TOWN CENTER STREET GRID CADASTRAL CONTROL STUDY REPORT CITY OF WILDWOOD

CDG Project No. 97002

September 29, 1997

TOWN CENTER
 CITY OF WILDWOOD, MO
 TRUCK TURNING STUDY 2/8
 ASASHTO WB-40 TRUCK

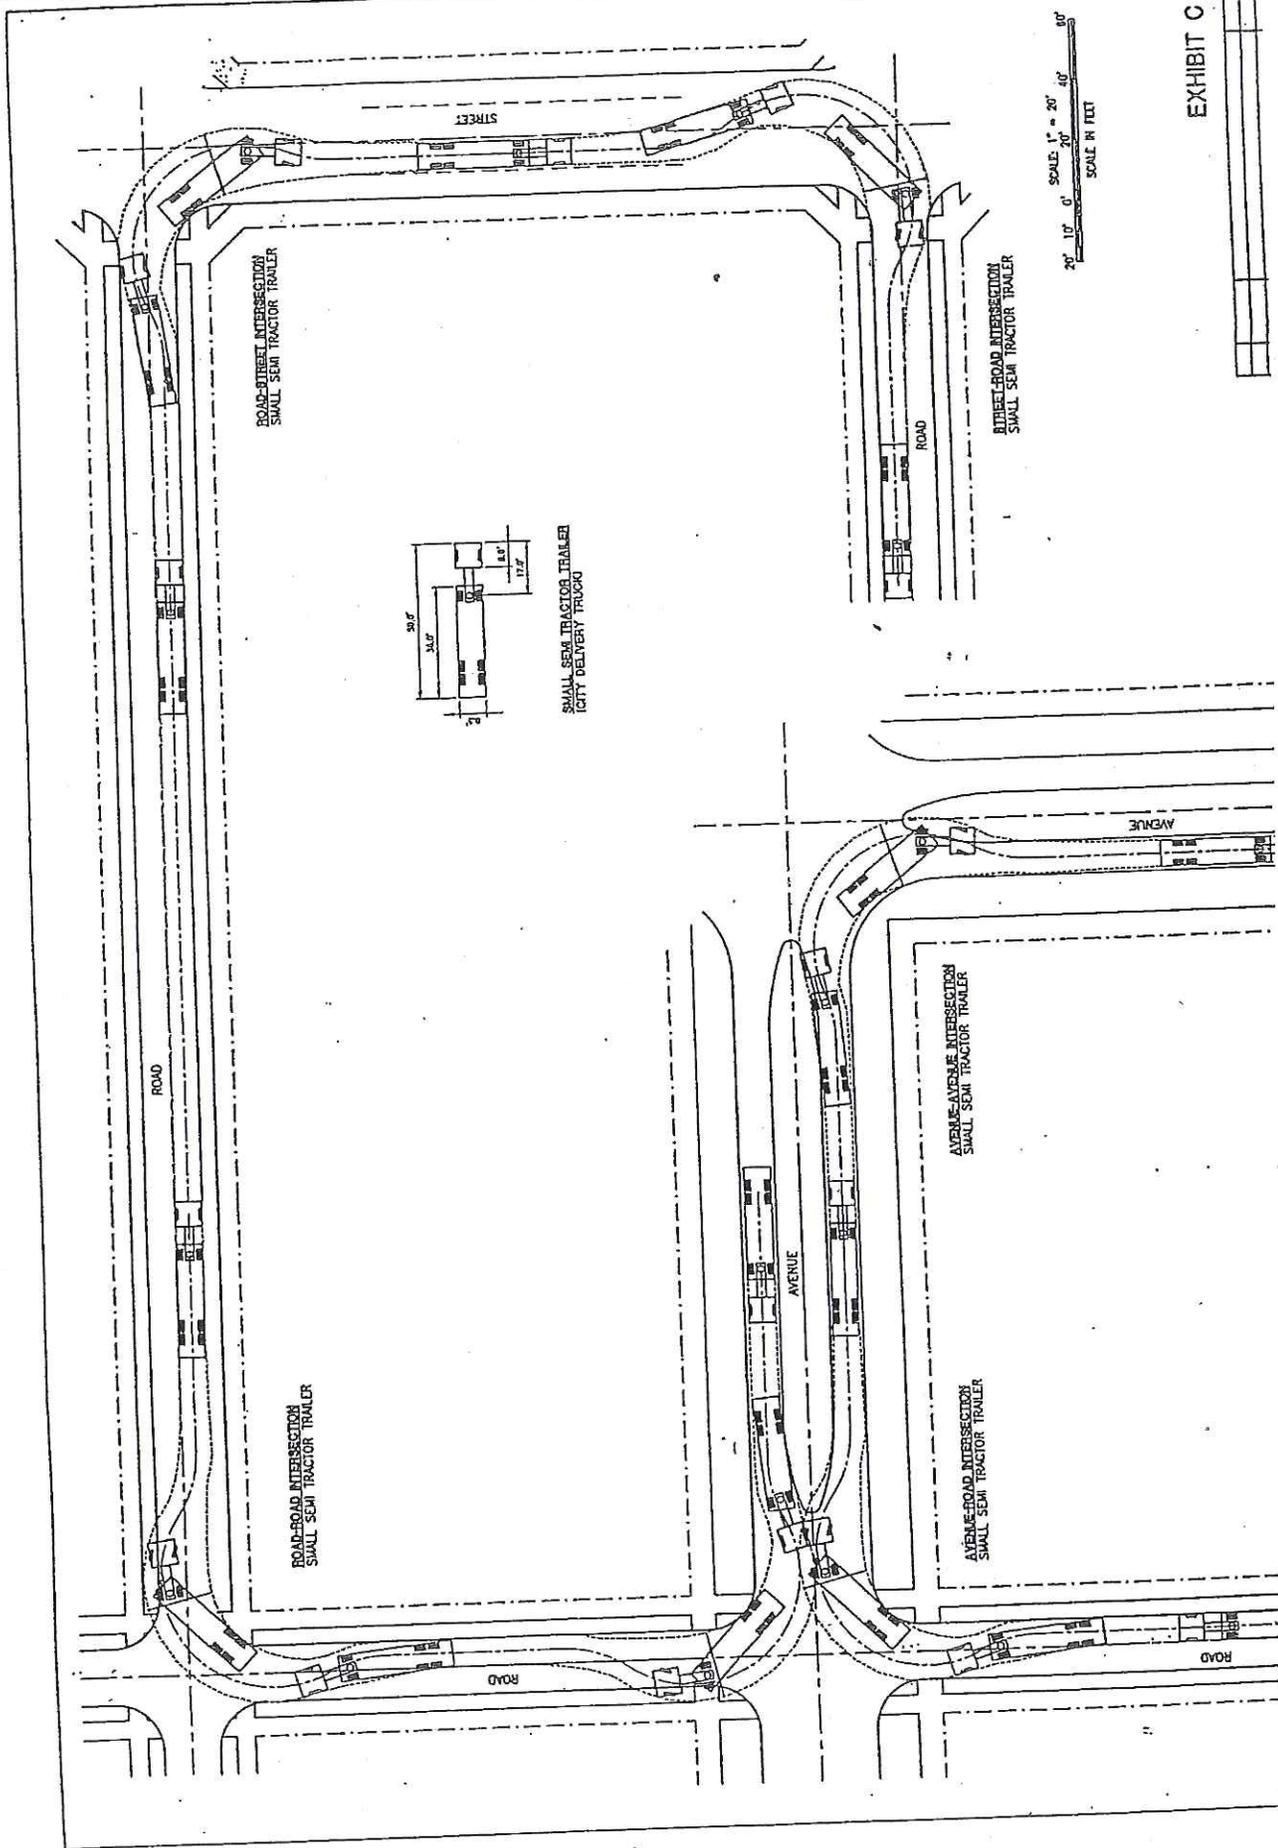
- The results of the truck turning analysis indicate that fire trucks and school buses will be able to negotiate the anticipated turns in one turning movement.
- Small tractor trailer rigs (City delivery vehicles) with total length of less than 50' will be able to negotiate all anticipated turns in one turning movement.
- Large over- the-road tractor trailer rigs (typically used by moving companies) will not be able to negotiate all anticipated turns in one turning movement. It will be necessary for these vehicles to "back down" and make the turn in three movements.
- The following Exhibit D illustrates the proposed intersection configuration and shows the proposed curb rounding radii.

TOWN CENTER
 CITY OF WILWOOD, MD
 INTERSECTION GEOMETRICS
 RADA AND LANE WIDTHS 2/2

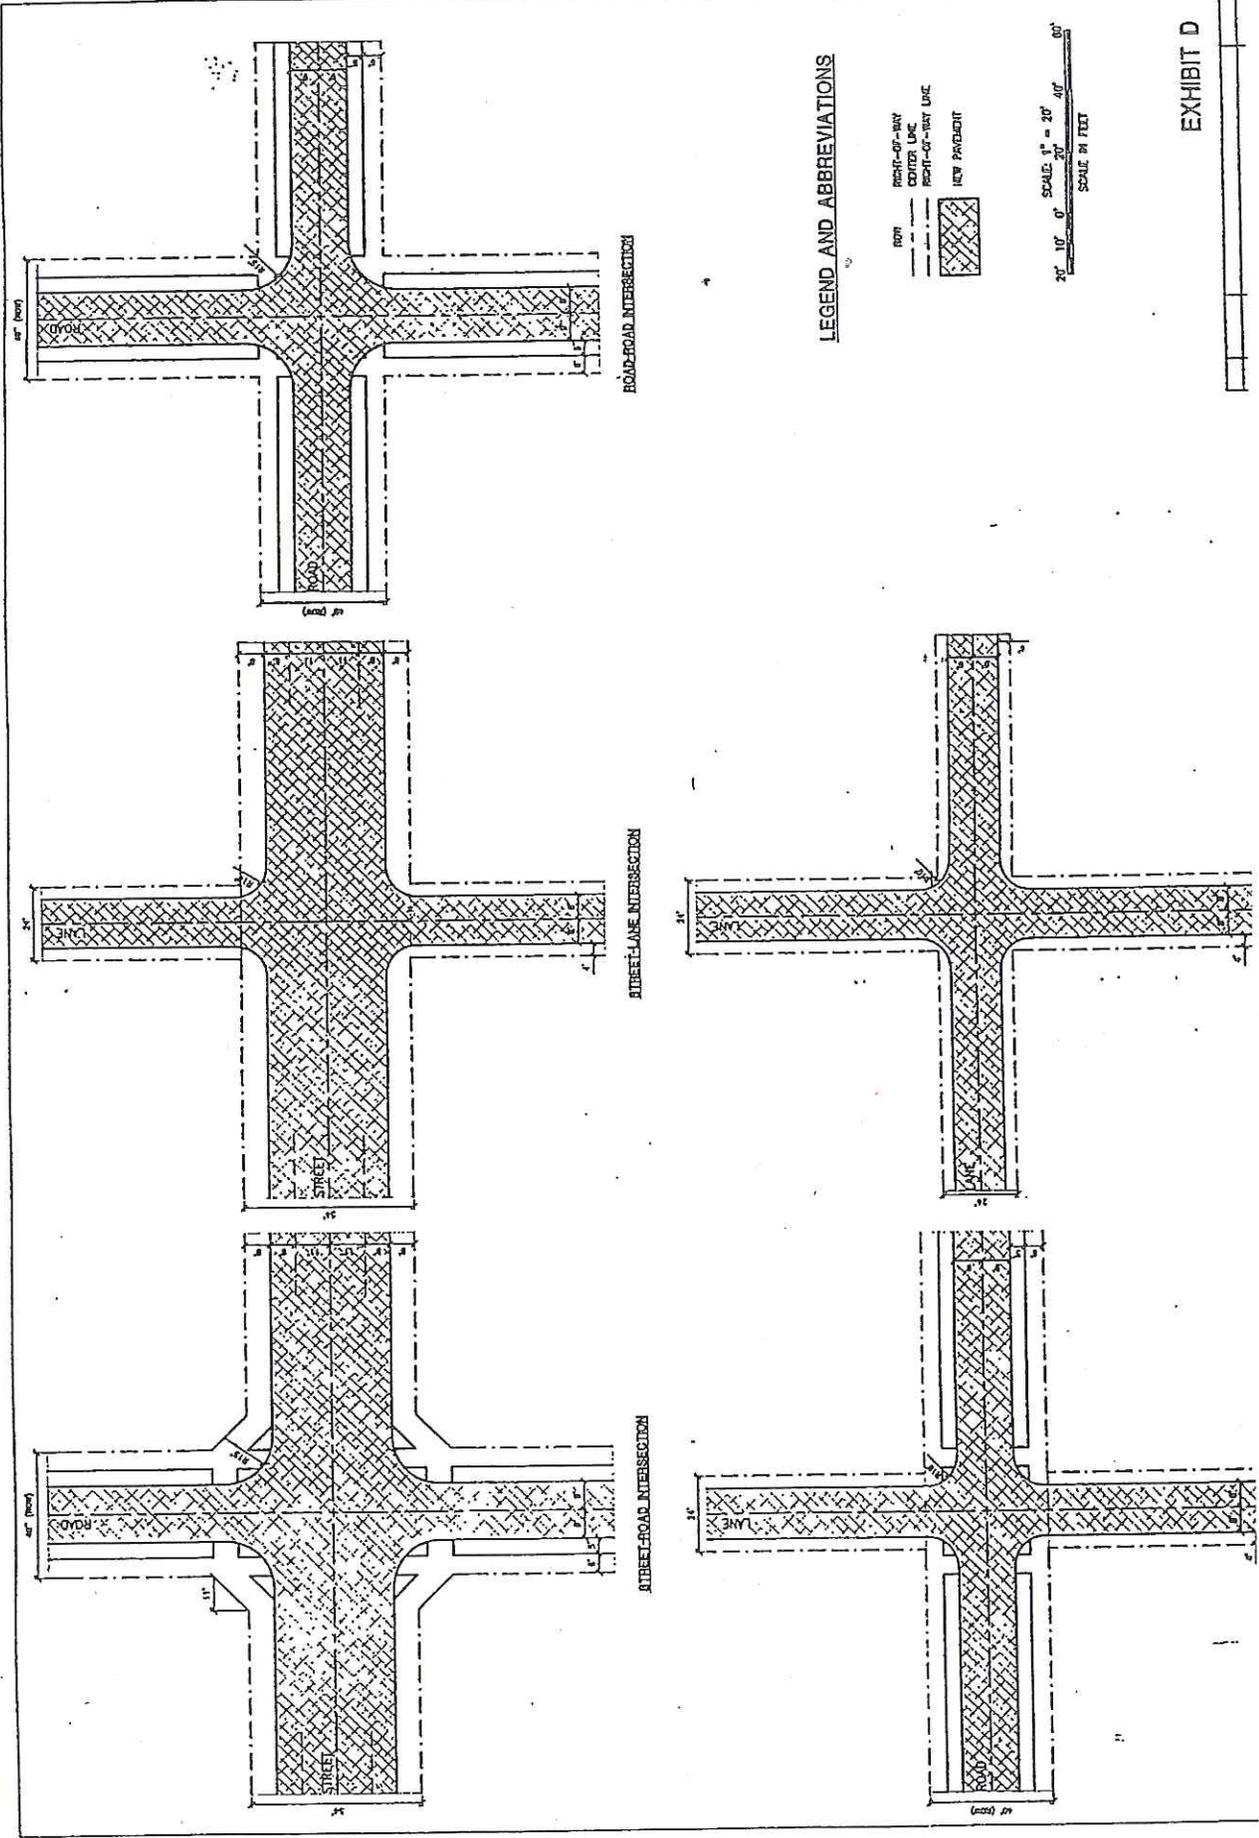
- The proposed extension of Lindy Drive North was terminated at Niere Acres Road West.
- The curb roundings for street intersections, as illustrated in this report, represent the bare minimum required in order to allow school buses and emergency vehicle access. This is in keeping with the Town Center Committee's instructions.
